July 17, 2009

Mr. Matthew Naud, Environmental Coordinator
City of Ann Arbor
100 North Fifth Avenue
Ann Arbor, MI 48104

Re: Evaluation of the Report on Water Level Testing Under Reduced Flow Conditions, Pall Life Sciences – Evergreen Area

FIGURE
6

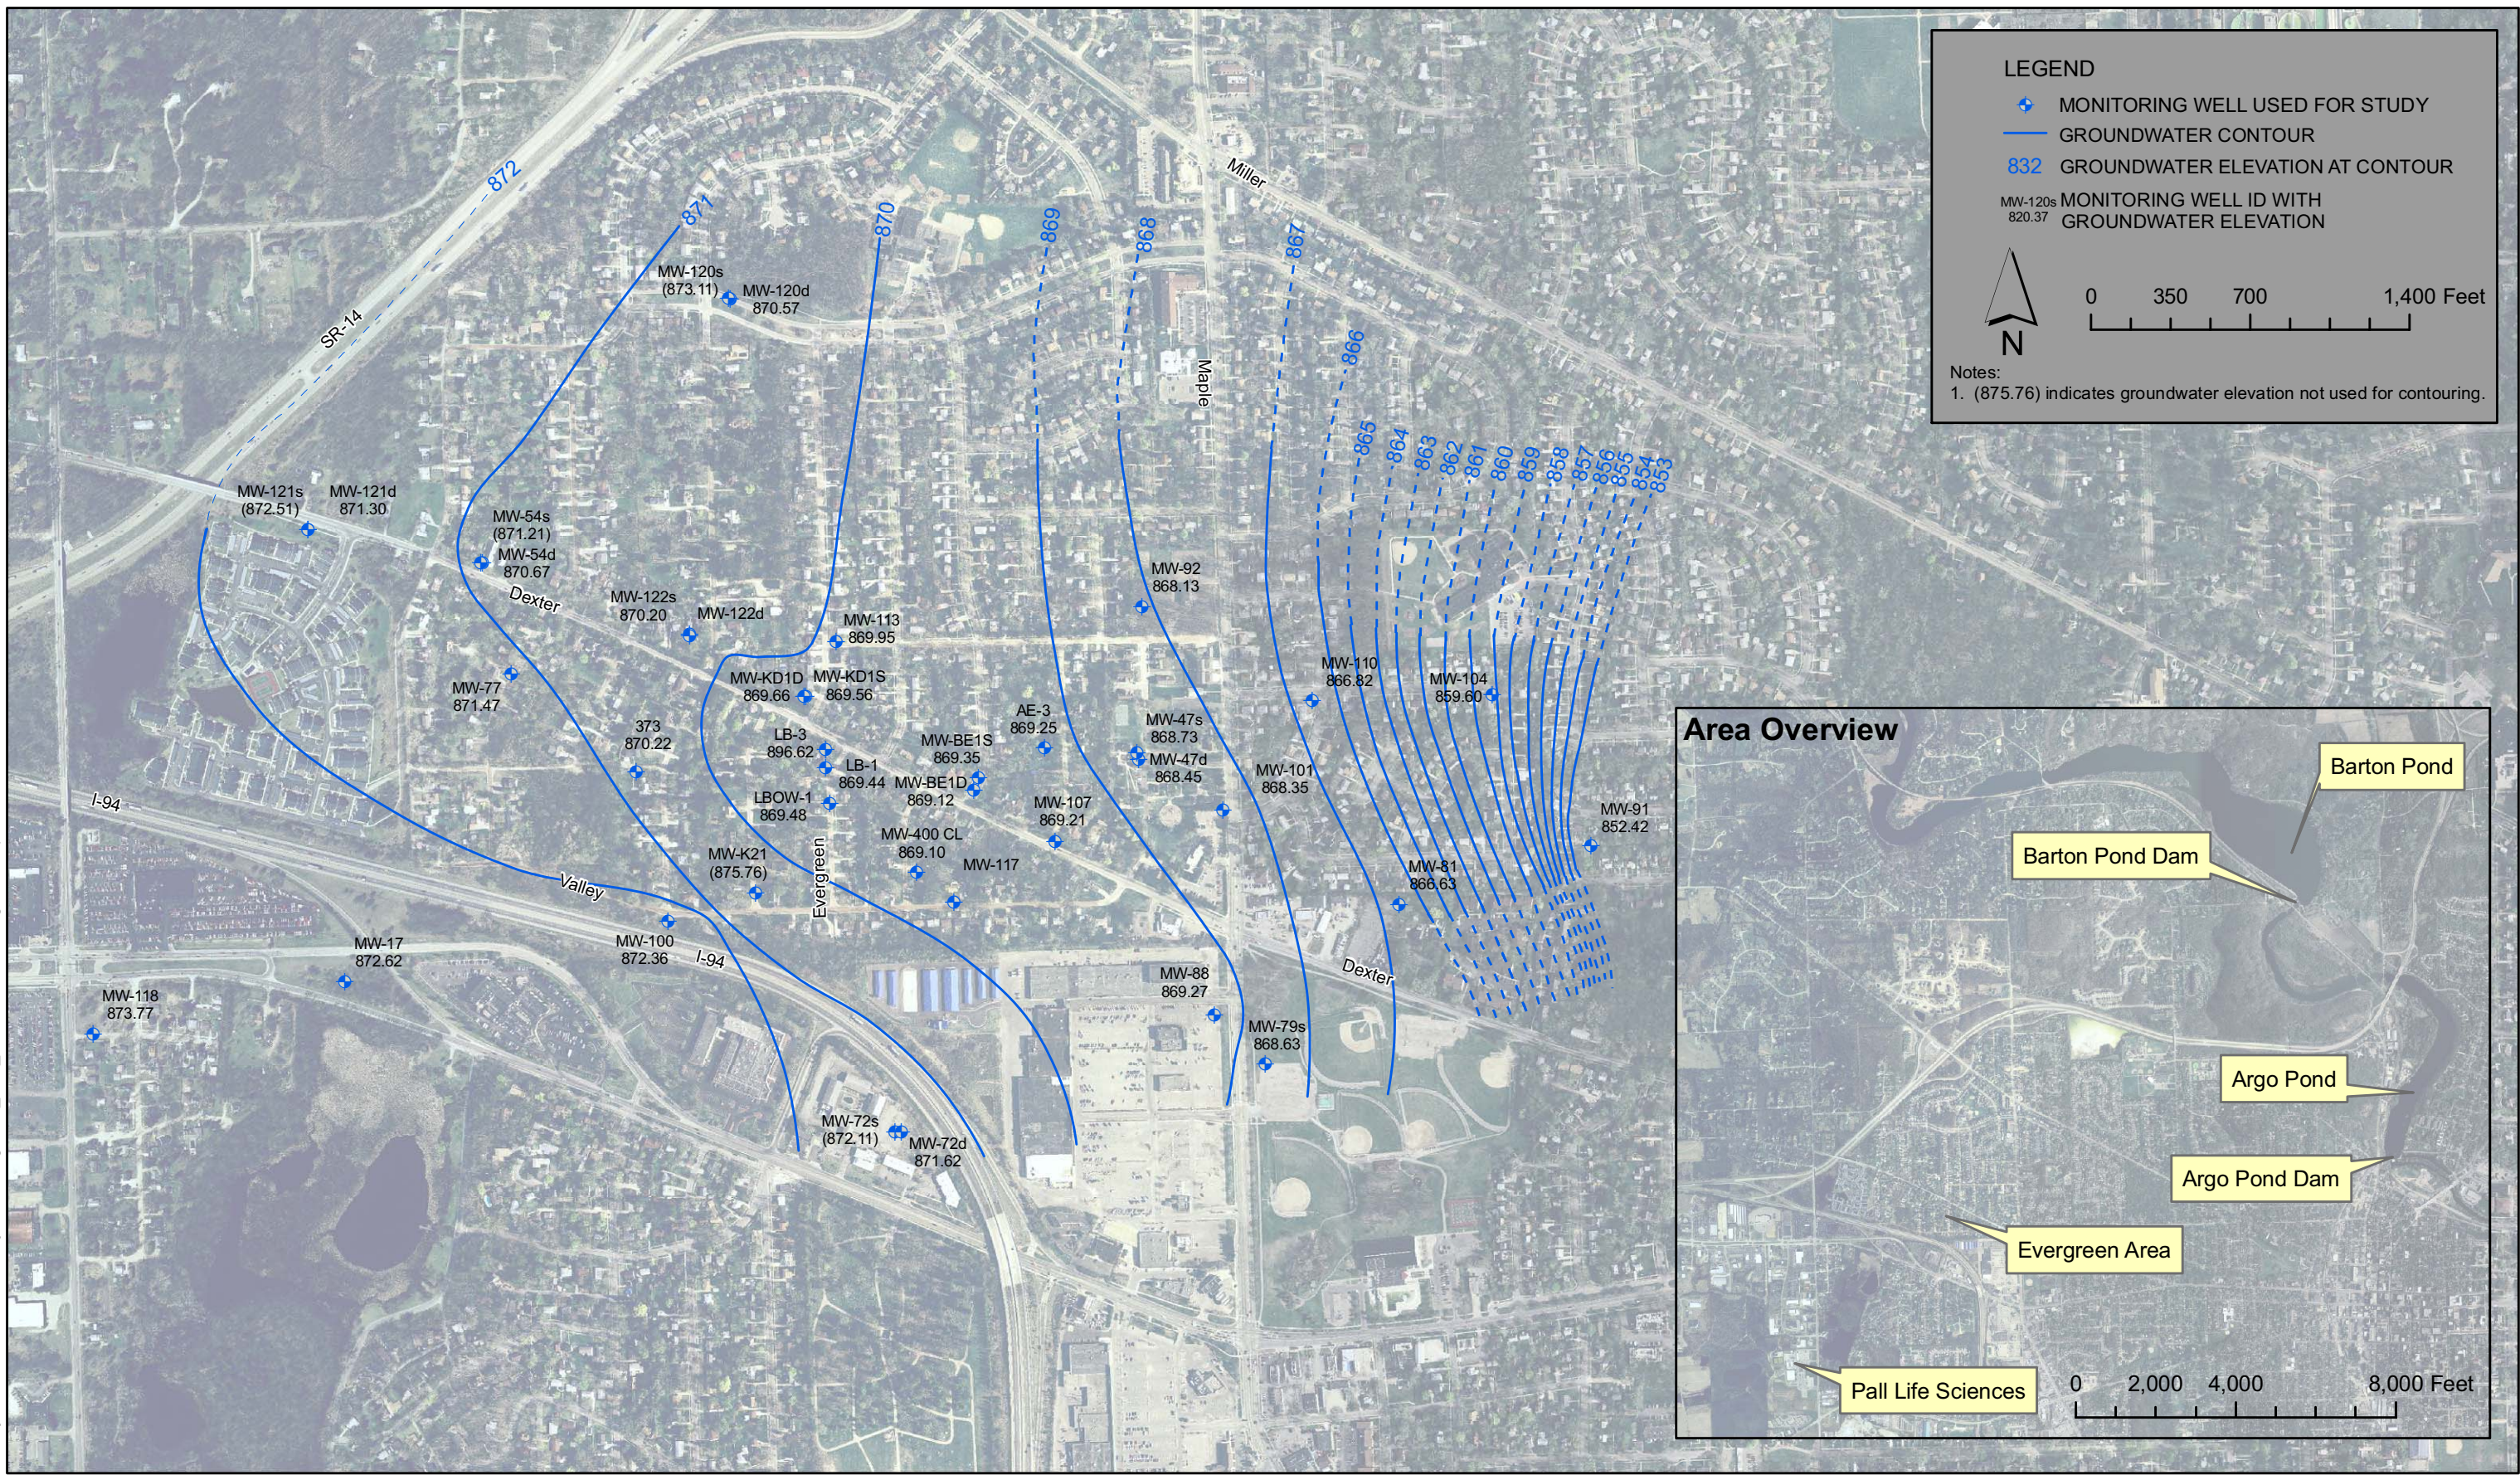
The potentiometric surface maps generated from the static water levels are highly dependent on which MW-120 well is used for contouring. As stated earlier, the shallow well will typically have a higher water level than the deeper well in this area due to the overlying contribution from recharge. The more conservative approach would be to use the results from MW-120D rather than those from MW-120S. A different interpretation of the potentiometric surface map from February 16, 2009 is presented in Figure 6. The changes are primarily the result of using MW-120D instead of MW-120S, MW-72D instead of MW-72S, and including MW-100. With this interpretation, groundwater north of the MW-77 appears to be directed to the east rather than to the south as depicted in Figure 8 of the Water Level Testing report. Yet another interpretation of the same map is presented in Figure 7 in the same manner as Figure 6, but using the average water elevation from MW-120S and MW-120D. Using this average instead of the low value from MW-120D reintroduces a southerly hydraulic gradient, though not as steep as that presented in the Water Level Testing report.

An easterly groundwater flow direction suggested by the potentiometric surface maps in Figures 6 and 7 is consistent with the observed 1,4-dioxane sampling results as posted on the cross-sections in the Water Level Testing report. Both pieces of evidence suggest easterly flow in the absence of pumping and are consistent with a conceptual model that the predominant preferential flow path for groundwater to reach the river is through a sand and gravel unit directed to the east in the vicinity of the Evergreen Area extraction wells. It seems reasonable that the D2 Unit plume will continue to migrate to the east and downward until it merges with the E Unit plume. Conclusive evidence of this conceptual model however is not presented in the reviewed document, and it is possible that groundwater in the D2 Unit and/or the E Unit east of MW-92 and MW-101 could migrate to the northeast if the sand and gravel units provide a pathway in this direction. It is further noted that the water level measurements and the interpreted groundwater flow directions may be dependent on the amount of recharge occurring at the time and that different groundwater flow directions may occur during different times of year or different weather conditions.
